AGENDA  
City of Milton  
Virtual Plan Commission Meeting  
October 6, 2020  
4:00 pm

**To:** Mayor Welch, Milton Plan Commission  
**From:** Howard Robinson, Director of Public Works  
**Date:** October 6, 2020  
**Subject:** Public Hearing, Discussion and Possible Action Regarding a Site Plan Review and a Conditional Use Permit for 401k Properties Located at 645 College Street.

**To:** Mayor Welch, Milton Plan Commission  
**From:** Howard Robinson, Director of Public Works  
**Date:** October 6, 2020  
**Subject:** Discussion and Possible Action Regarding a Site Plan Review for a Dairy Queen at 1167 Gateway Drive.

ANY CONSTRUCTION DEBRIS/MUD TRACKED ON TO PUBLIC STREET SHALL BE REMOVED NIGHTLY

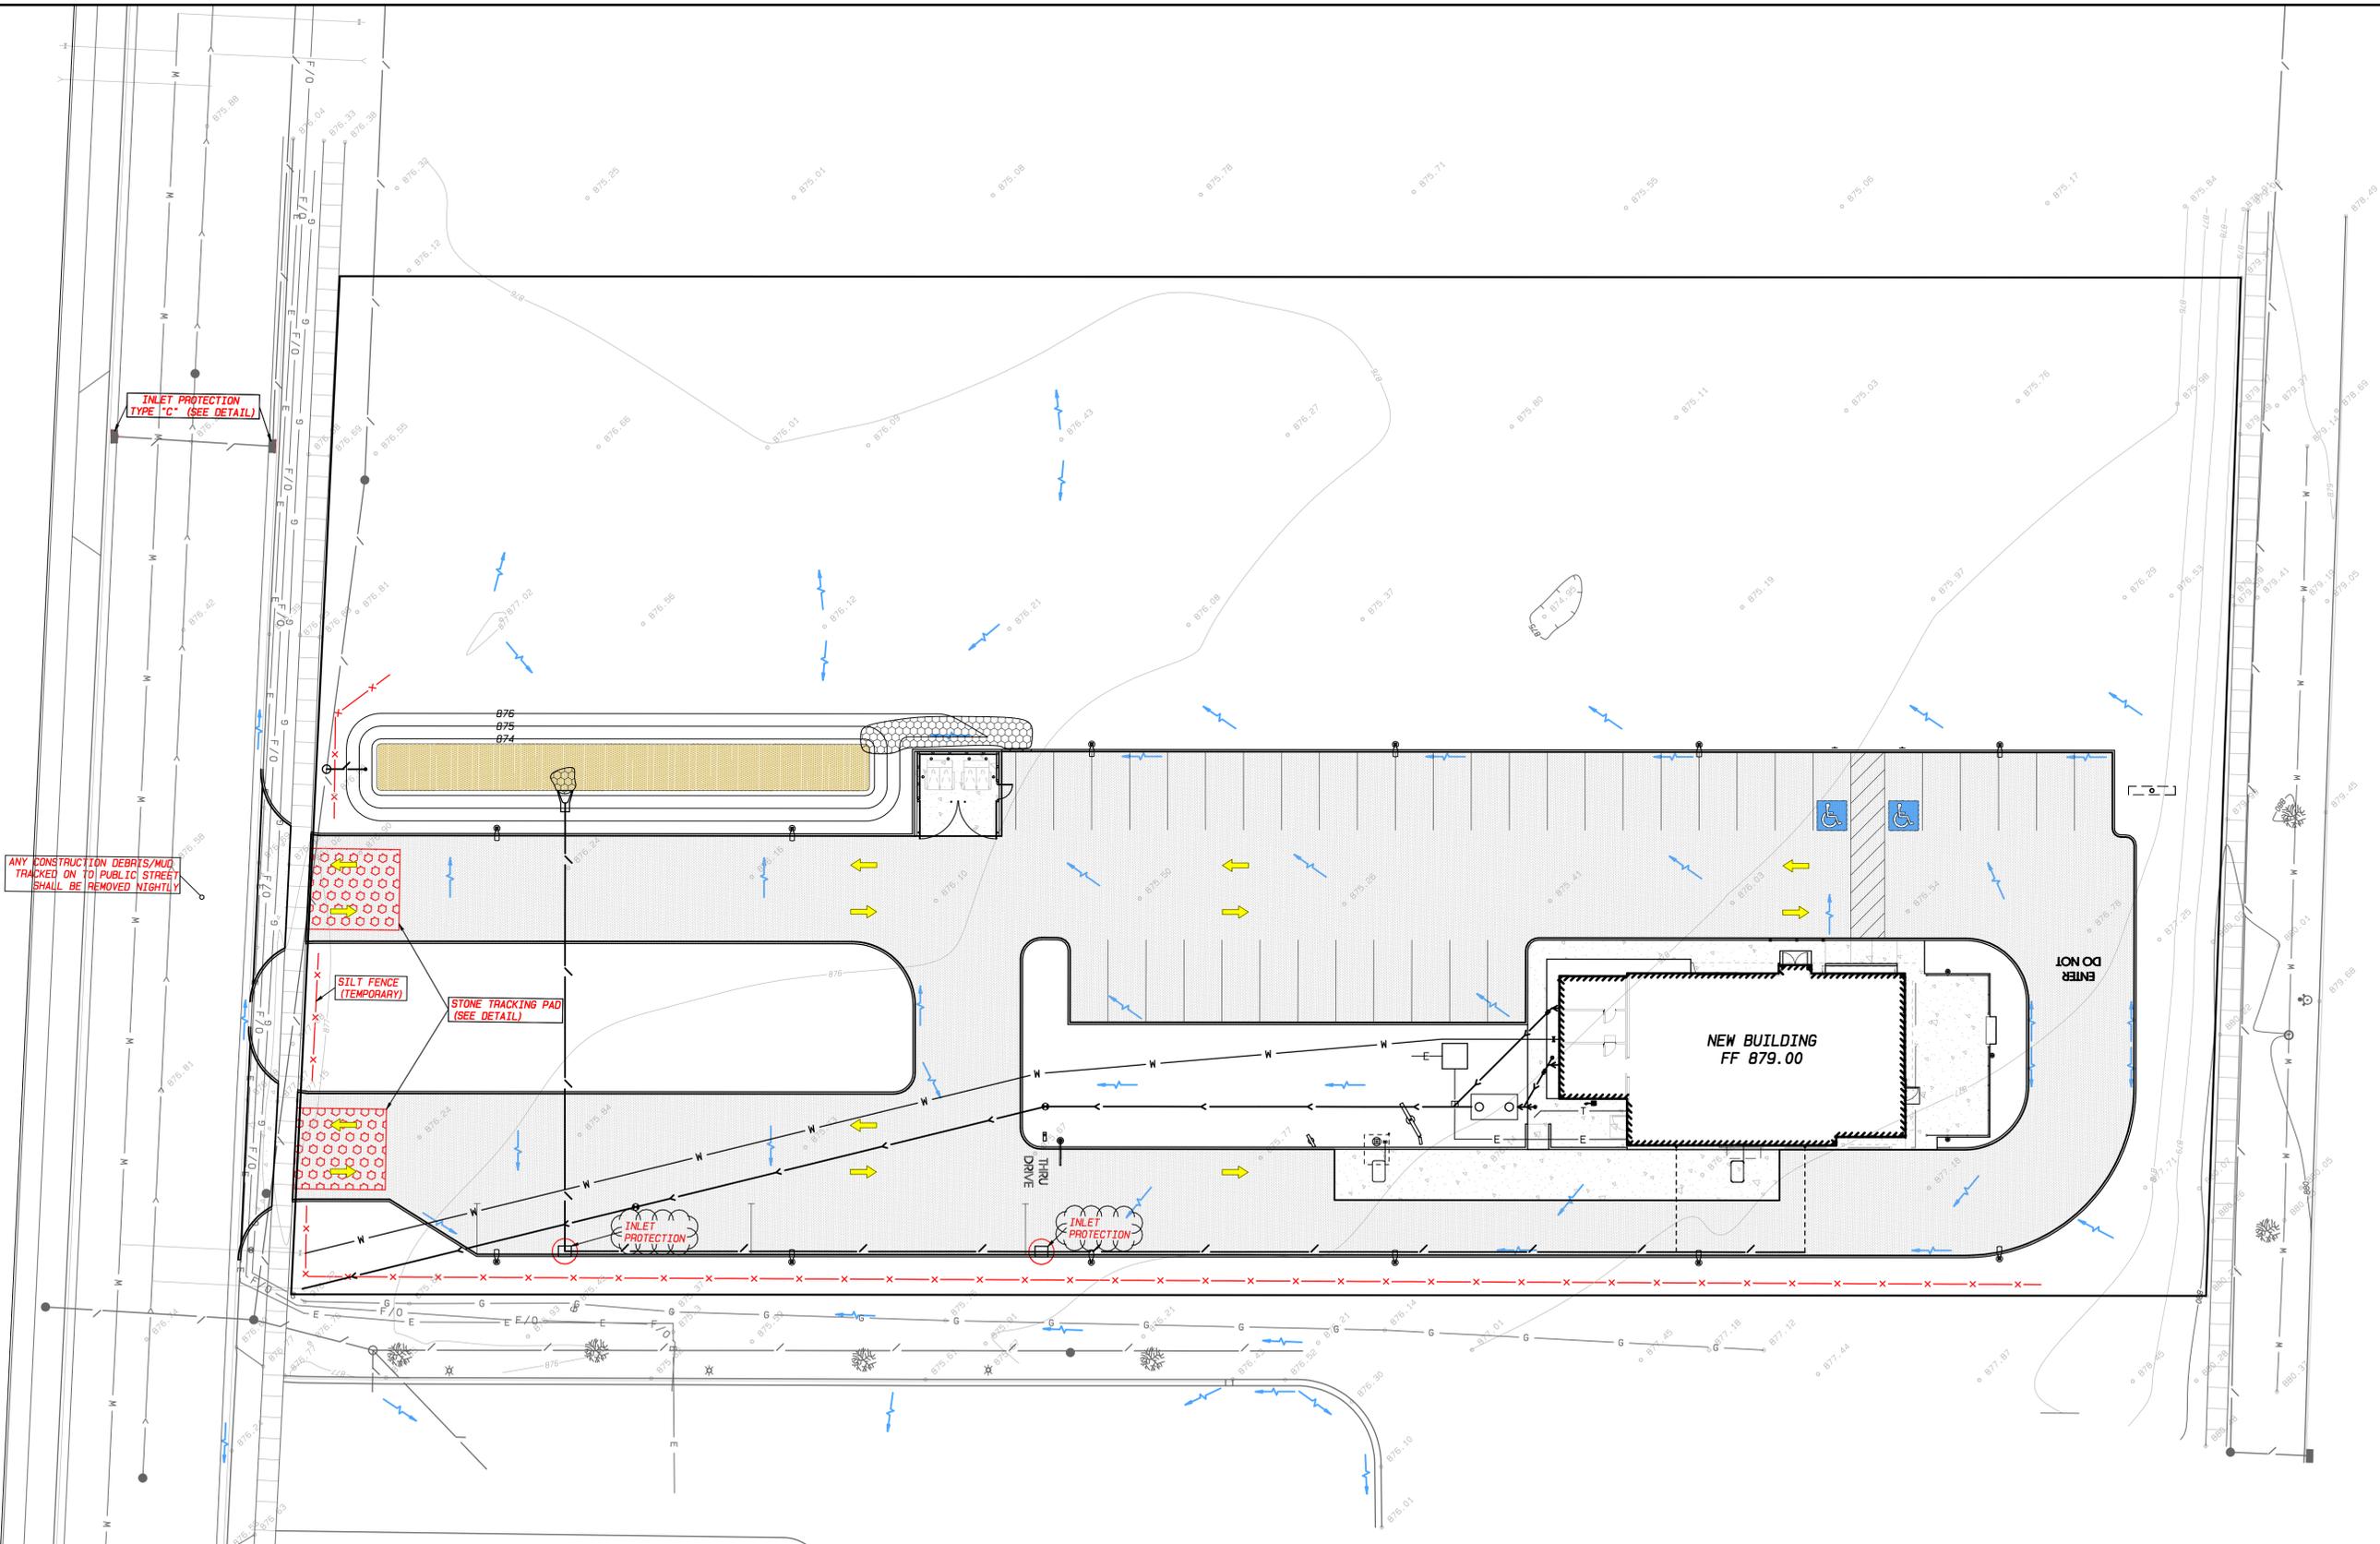
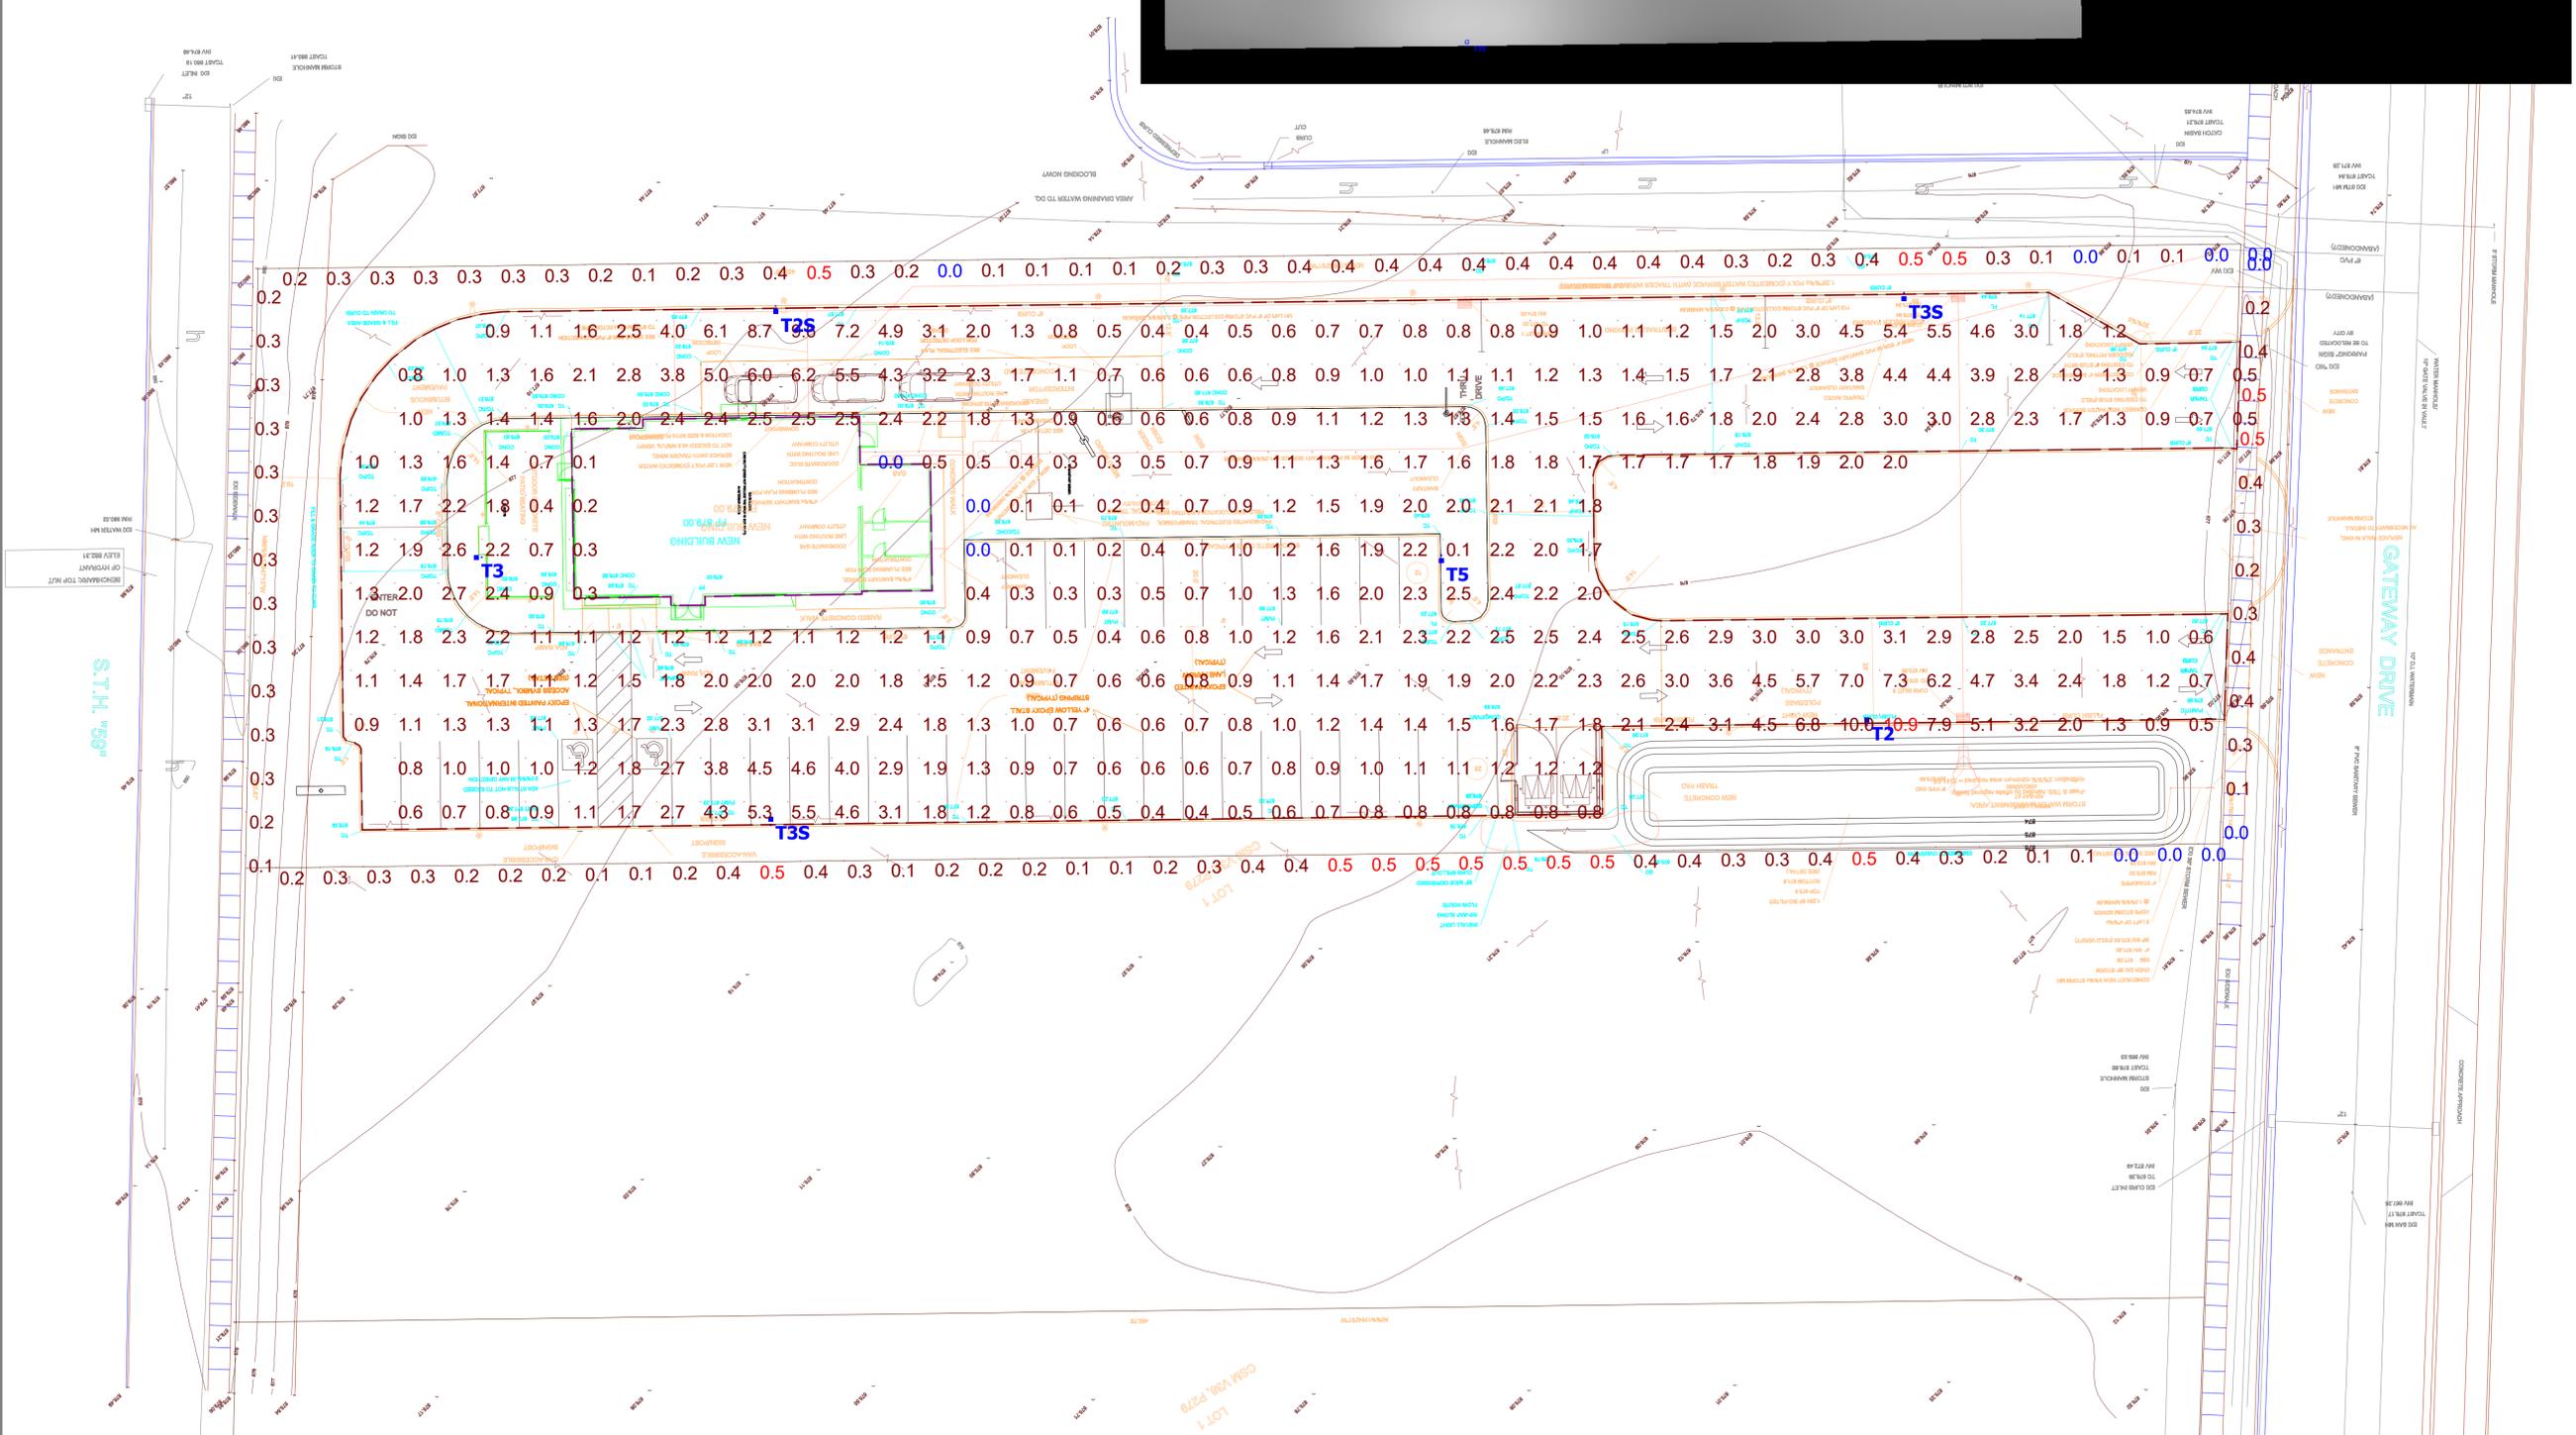
A Dairy Queen is planned to be constructed at 1167 Gateway Drive. This is the lot east of Kwik Trip. The lot is zoned B-2. A site plan has been submitted. The site plan will meet ordinance requirements with the contingency of completing the following items for the site plan:

- Storm Water Plan - Required to indicate revision dates and language describing the drainage pipes, mains, inlets, cleanouts, etc.
- The biofilter (onsite stormwater area) can only be mowed to a height of no less than 6". City Engineer Mark Langer will verify these corrections when submitted.
- Roof top HVAC units will require screening..

City staff recommends approval of the site plan with the above contingencies for a Dairy Queen at 1167 Gateway Drive.
